AMBER VALLEY BOROUGH COUNCIL
RECEIVED
18 MAY 2021
2

I am replying to your e-mail of 10th May 2021 relating to an application for a dropped kerb at 79 – 81 Pentrich Road.

91 PENTRICH ROAD
BOUNDARY TO 91 PENTRICH ROAD
Existing
Site Plan
Dwg No: 1
Scale 1:50
EXISTING DRIVEWAY ACCESS
EXISTING DROPPED KERB
1.62m
81 PENTRICH ROAD
4.25m
EXISTING FOOTWAY
4.5m
79 PENTRICH ROAD
4.32m
BOUNDARY TO 77 PENTRICH ROAD

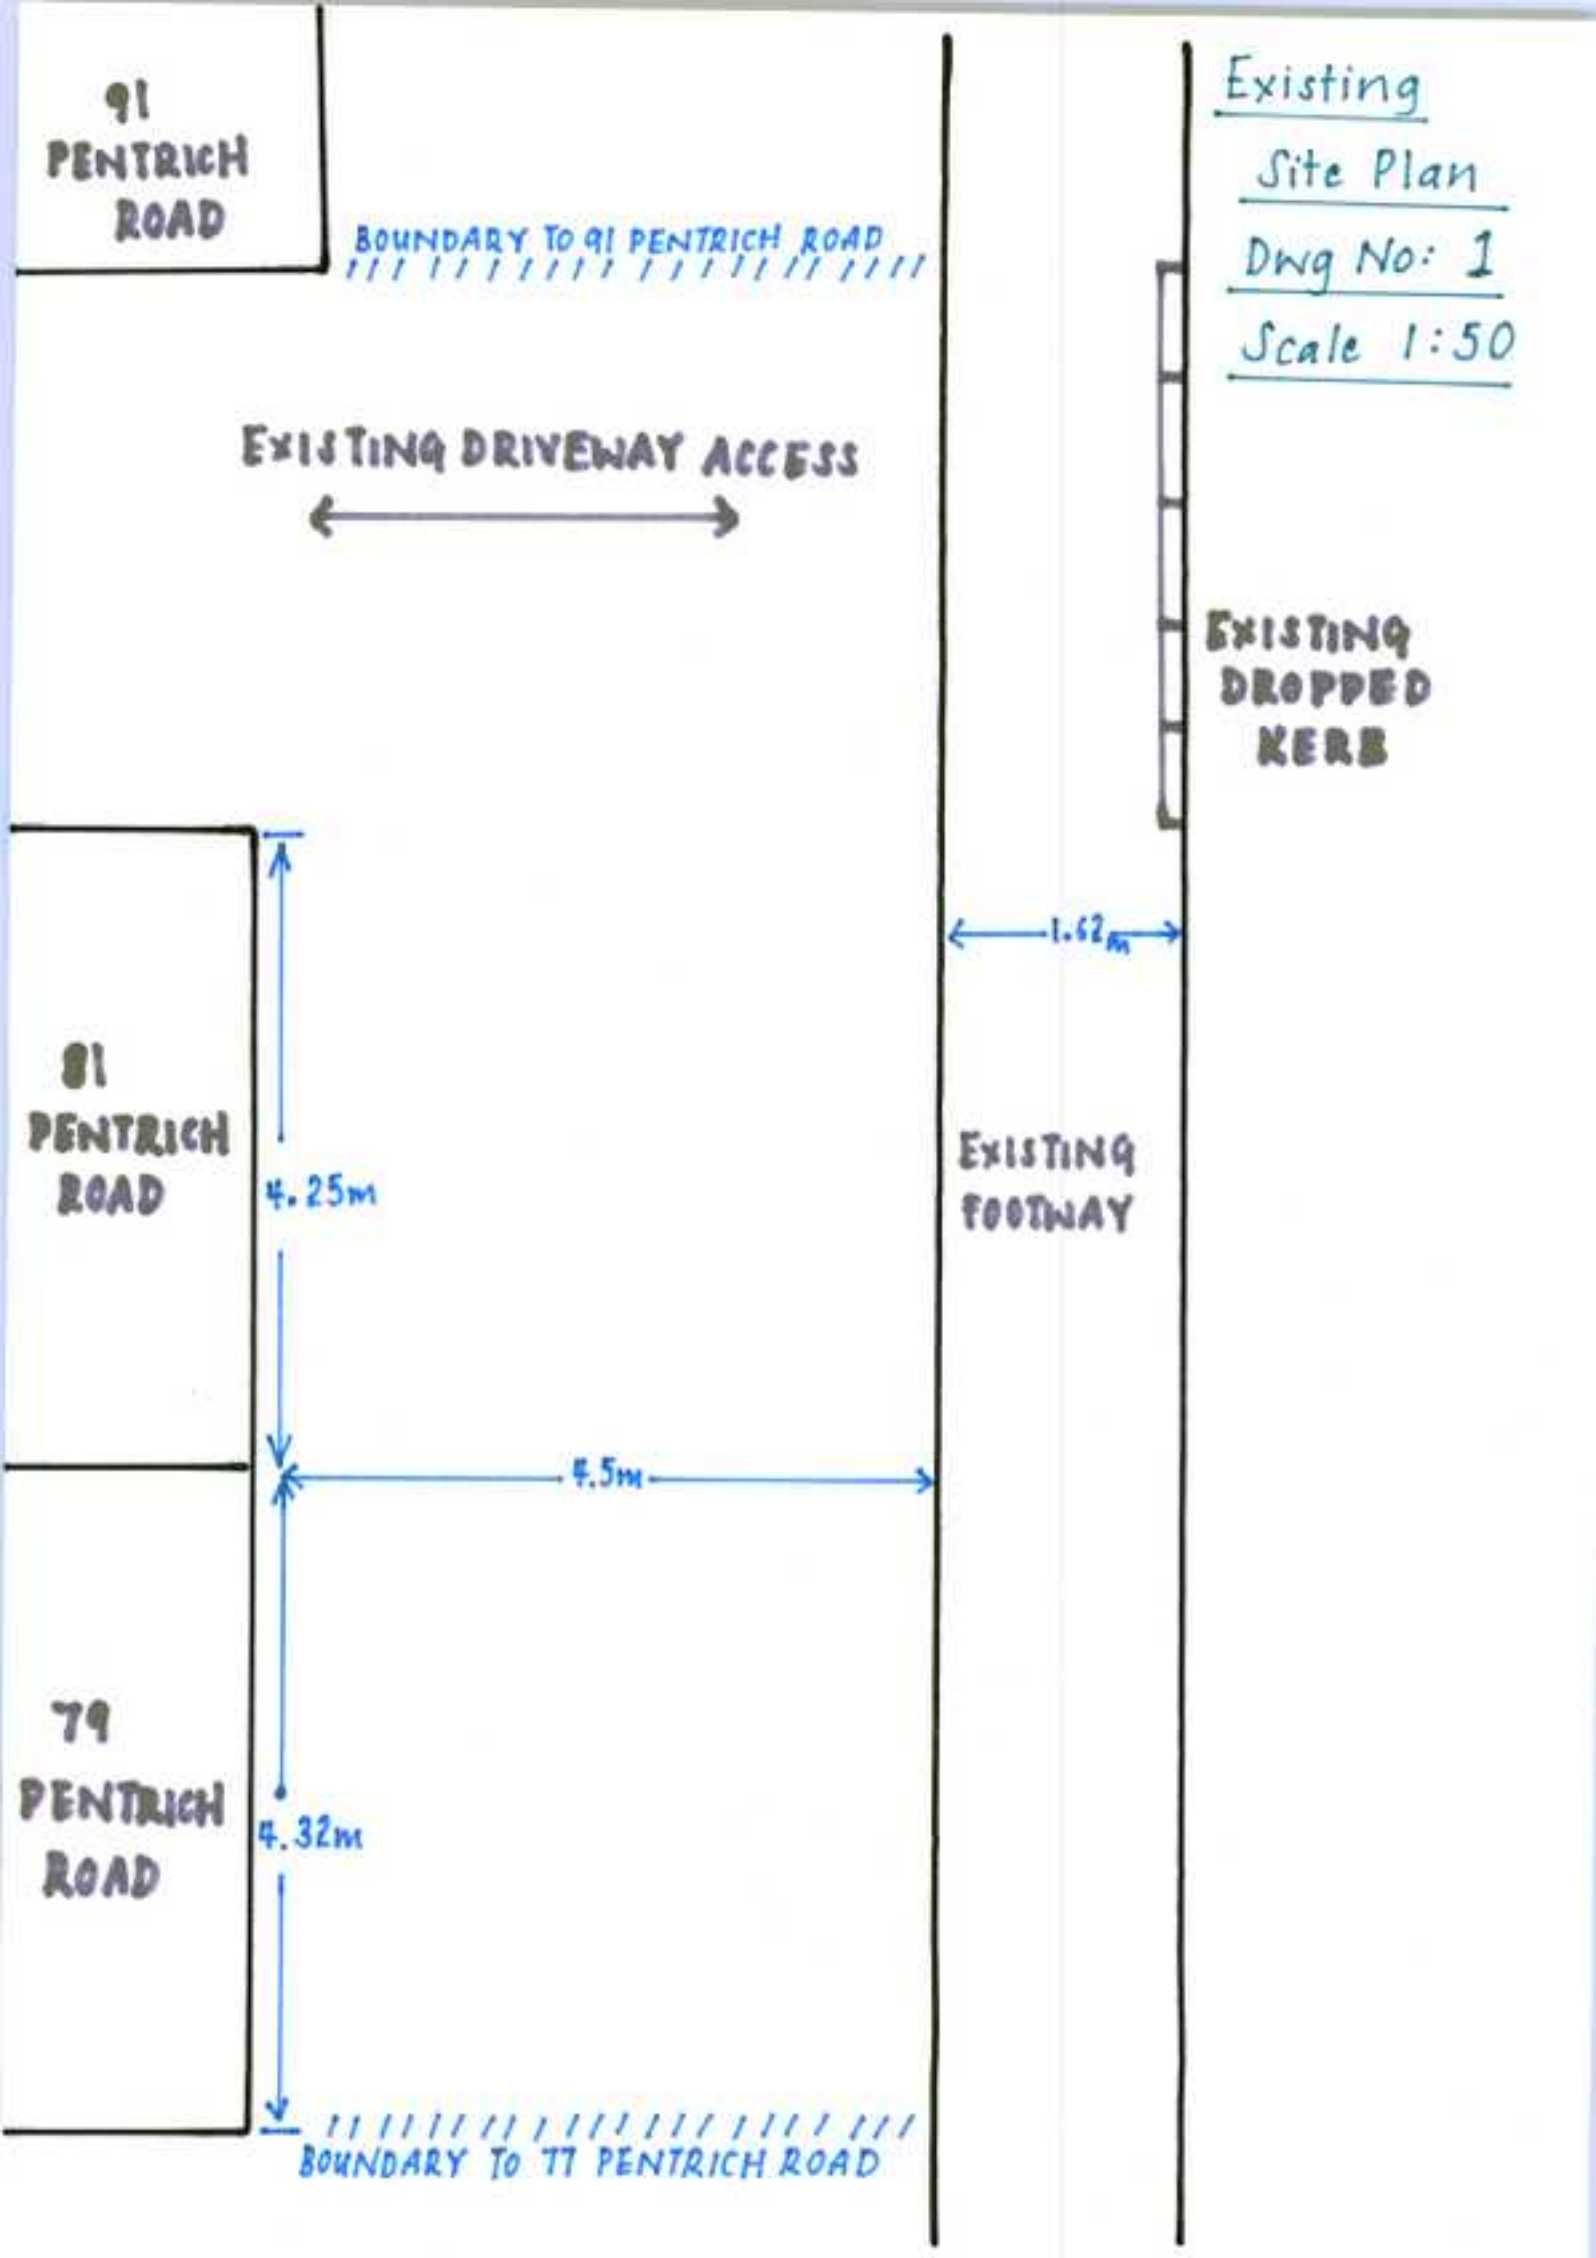
The Highway Authority area requesting a plan demonstrating 5.5m from the principal elevation of the dwellings and the edge of the pavement, where your land joins the pavement and also a plan showing visibility sightlines of 2.4m x 43m in both directions.

I have drawn up a plan, which is to a scale of 1:50 and it shows the dimensions of the land to the front of No's 79 and 81 Pentrich Road in between the principal elevation of the dwellings and the edge of the pavement. This is the ***Existing Site Plan – Drawing no. 1.*** I have also drawn up a plan which shows the extent of dropped kerb that I would like planning permission for and this extends across both properties and is shown in ***Proposed Site Plan – Drawing no. 2.*** Please note that I will hand deliver all of the plans referenced in this e-mail, directly to your offices.
